#3035857-LU 425 N 85th Street Recommendation Phase 7-16-2021 Greenbank Holdings LLC

425 N 85th Street SDCI# 3035857-LU

SCALE: NTS **2** 425 N 85th Street / #3035857-LU /Recommendation Phase / 16 July 2021 Greenbank Holdings LLC + SHW

EDG Massing Concept

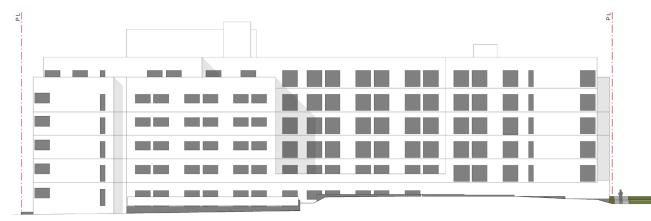
At EDG, staff appreciated the stepped massing on all sides and asked the Applicant to explain the design intent for south facing facades. They also encouraged the Applicant to look at varying window types to help further enhance the massing moves and introduce balconies or other secondary architectural elements to provide more texture to the facades that face the singlefamily homes.

Following MUP, the guidance was to revise the design to provide a cohesive concept where random and staggered elements and fenestrations that are not found on the other facades of the building were introduced. The Applicant concluded:

- The light-colored, small-scale plank siding was the appropriate material where closest to residential neighbors, however, the window groupings were modified to reflect patterns seen on the other sides of the building.
 - The courtyard facades were modified to replace the staggered windows and infill panels with a more rigourous, stacked configuration. The juliet balconies remain alternating to create large scale visual relief on a long facade and to offset openings in adjacent units.

View of NE Corner - solid parapet (proposed)

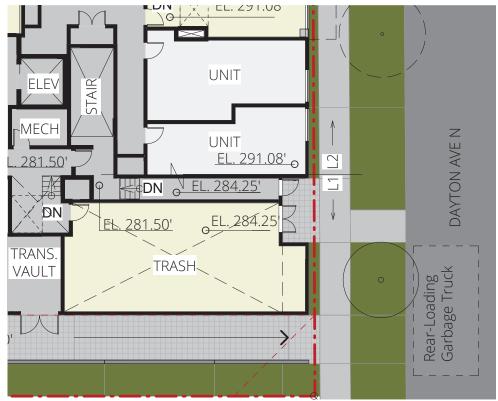
At EDG, staff recommended looking at the treatment of the various parapets around the building. During MUP review, the Applicant was asked to study partial or full open railings at the NE and NW brick massing to add texture and smaller detail elements. It was agreed that the lowered parapet around the entirety of the primary roof level was successful in reducing height, bulk and scale.

The studies show the proportions and hierarchy of stepping and articulation is disrupted by the addition of railings. The brick corners act as anchors and are already dropped from the primary massing to reduce height, bulk and scale. See listed Design Guidelines that support the proposed option.

EDG Scheme C - Partial Plan

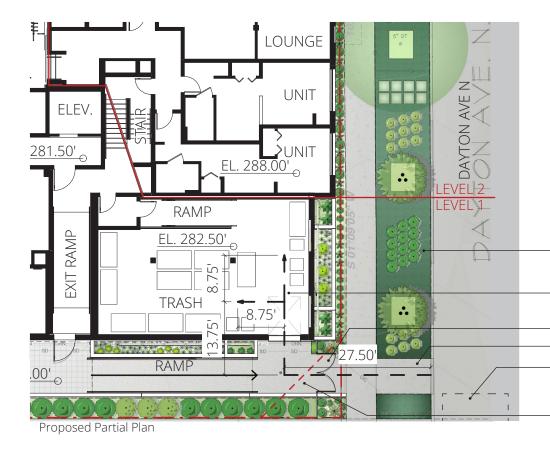
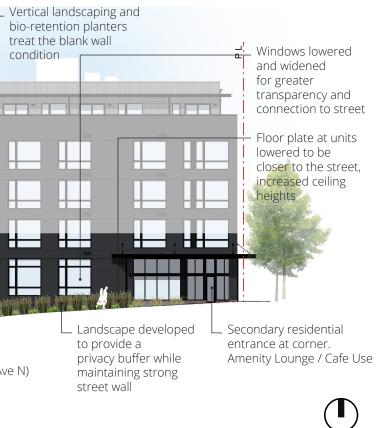
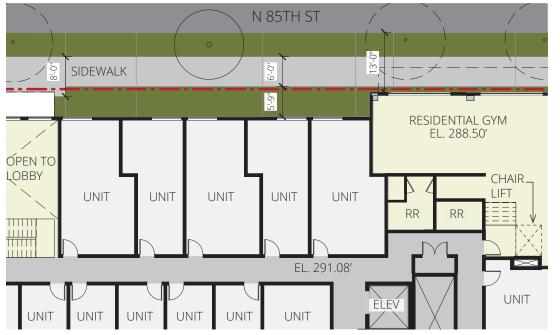
At EDG, followed by supplemental guidance at MUP, staff recommended:

- Increase the number of units that face street by moving trash room to a more internal location. Possibly rearranging to allow for a unit parallel to Dayton.
- Utilize the wide service path on the south side to get trash out to the street (understand that the room needs to be within 50' from the street per SDOT requirements).
- Provided additional information/diagrams clarifying . SPU requirements and a clear narrative outlining why an internal room and a smaller staging area could not be used to help eliminate the blank wall condition on the street frontage.
- Describe how the units facing Dayton are better connected than those shown at EDG.

The Applicant concluded:

- SPU/SDOT approved configuration limits inbuilding pickup to the front 10 feet of the building. No additional units would fit parallel to Dayton and still maintain bin size, clearances and access requirements.
- Trash room access was configured to be concealed behind a service gate. A wider landscape buffer was provided facing the street.
- Interior circulation was revised to provide more accessible, less convoluted circulation in and out of the rear of the building. Floor plate stepping was refined with Dayton facing units connectivity in mind.
- In addition to the image on the right, see page 39 for more information.

EDG Partial Plan - Level 2

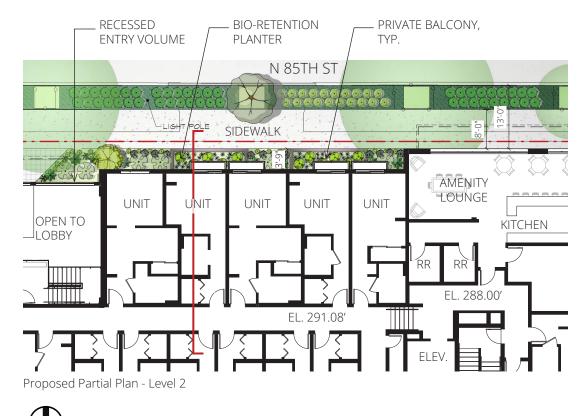
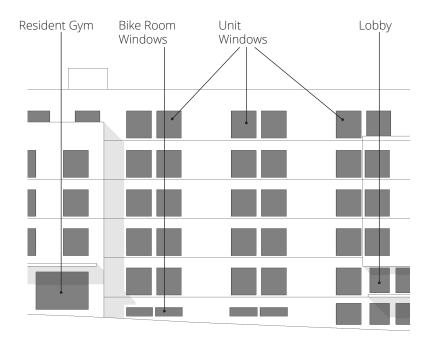
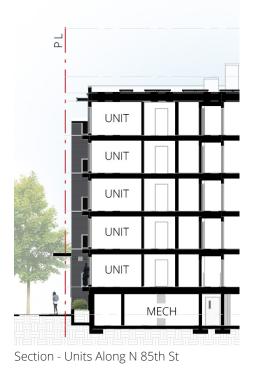
At EDG Staff was concerned that there was limited opportunity for interaction along N 85th St specifically at residential uses above the bike room. Understanding the complexities of the site slope the Applicant was asked to explore ways to promote interaction with the street such as creating terraces for the residential units.

- The sidewalk was widened from 6 ft to 8 ft per SDOT guidance.
- A more generous sidewalk width coupled with grade challenges limited usable space for unit entry stoops.
- Private balconies are arranged in bays to add architectural texture and rhythm.
- Unit windows are elevated from the street for . privacy and surveillance.
- . Bike room windows were removed and replaced with a healthy landscape buffer, including bio-retention planters, shrubs and ornamental tree.
- In addition to the updates to the units facing the street, the increased space provided at the primary building entry and change from gym to lounge/cafe at the NE corner encourage interaction at the streetlevel.

SITE PLAN

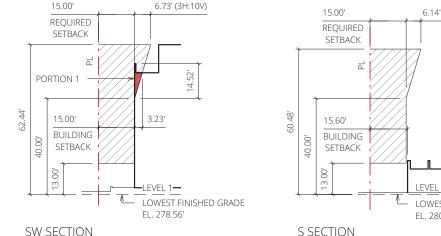
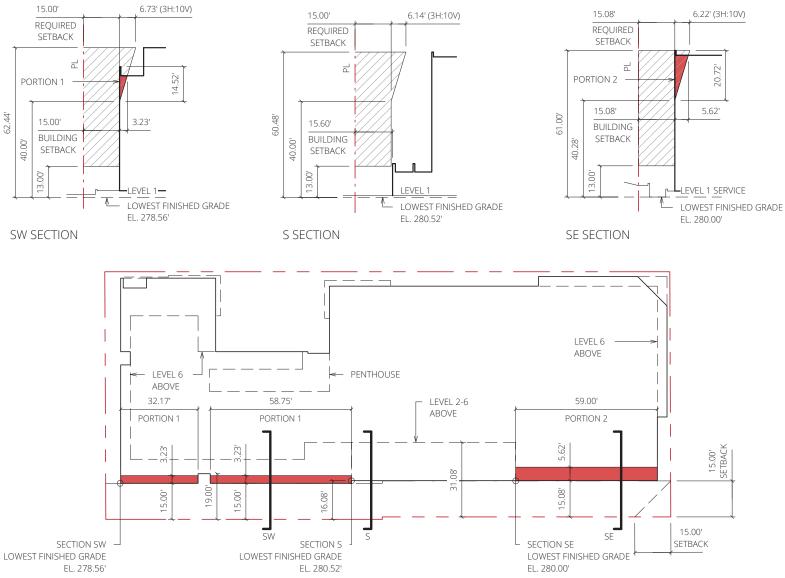
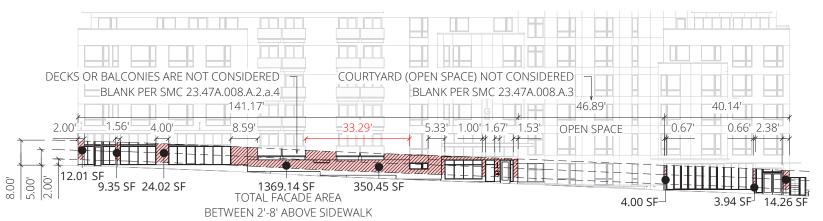
Required: Blank segments between 2'-8' above the sidewalk not to exceed 20' in width. Measurement taken from 5' above sidewalk.

Blank segments between 2'-8' above sidewalk not to exceed 40% of total area. Proposed: 33.29' blank segment where balcony is between 2'-8' but does not cross the 5' line of

measurement. Area of blank facade between 2'-8' is 43.36% of total facade.

MUP RELATED RESPONSE:

Per SMC 23.47A.008.2.a.4&5, balconies and landscaping on the facade itself are elements that make a segment not blank. Balconies are provided within this area but not within the line of measurement. Significant landscaping is provided, however bio-retention facilities do not support vine or climbing type plants. The design meets the intent, just not the very specific code language, thus a departure is needed
